**SAFETY  
RECALL**

**SR14-26A**

DATE :	JUNE 2014	SECTION :	18 - Body
SUBJECT:	SEAT BELT INSPECTION AND REPLACEMENT: AMAYA FLIP-UP SEAT

REVISION A: THIS SAFETY RECALL SUPERSEDES PREVIOUS VERSION.  
 Aug. 14, 2014: Torino G belt p/n was 864114, is 865023

Figure 3: Typical belt damage (Curb side seat)

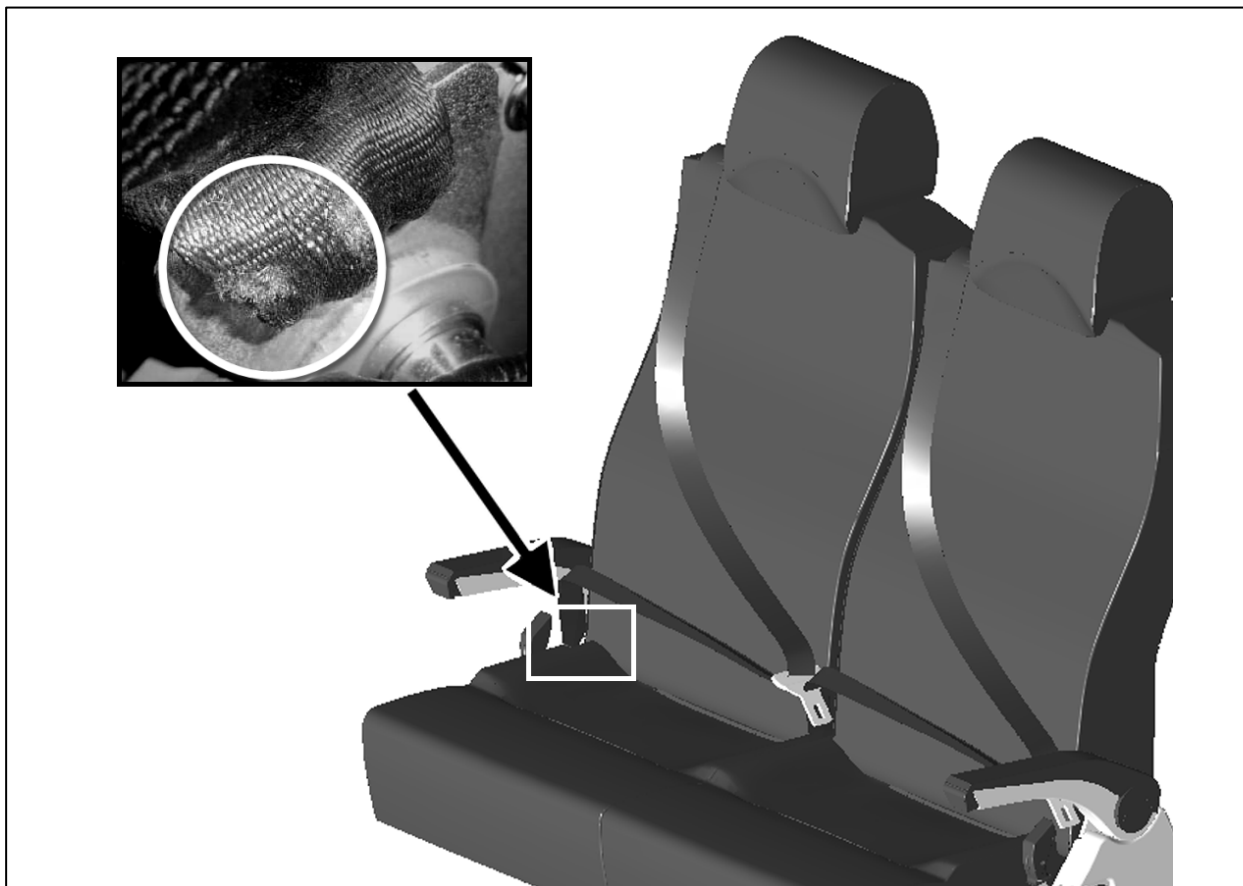
On the vehicles equipped with a wheel chair lift and AMAYA TORINO G or A210 (A2 TEN) flip-up seats (fig 1), the seat cushion frame when raised and lowered may rub against the seat belt anchor point on wall side. This presents a risk that the seat belt may be damaged over time and may fail if a crash occurs. If the seat belt fails during a crash, the occupant may be injured.

The outboard (wall side) seat belt anchor of all flip-up seats must be inspected for damage. (fig 2 & 3).

- If the belt is found damaged, the belt should be replaced and the anchor point must be changed.
- If the belt is found undamaged, the anchor point must be changed.

Figure 10: New position of belt anchor.

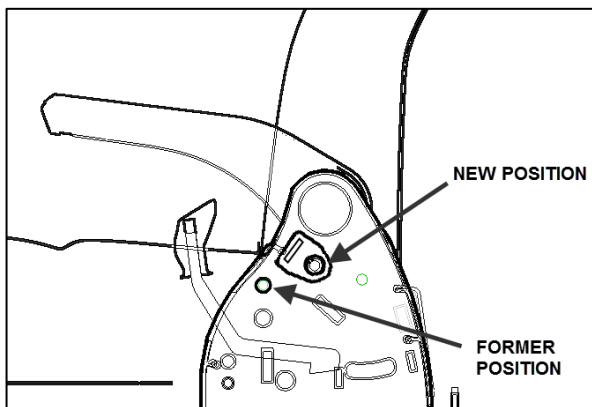
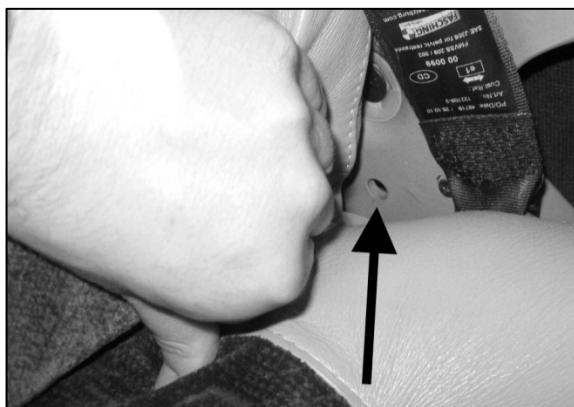
7. Re-install belt anchor in new location as shown, away from pivot. (Fig 10 & 11)

8. Belt anchor plate should be installed parallel to seat frame.

Install with:  
5001734 Screw  
500897 Washer  
500594 Nut

**Tighten to:35 lbf-ft**

Figure 12: New hardware and torque seal

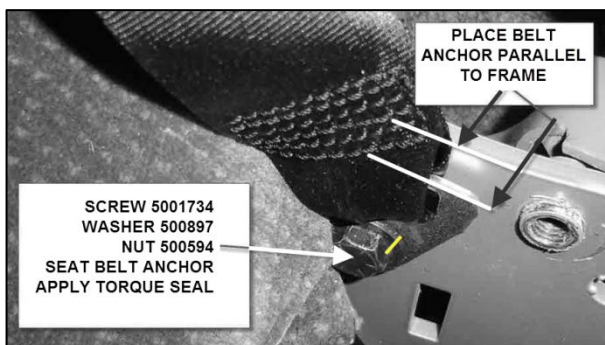
Apply torque seal mark to confirm belt relocation. (Fig 12)
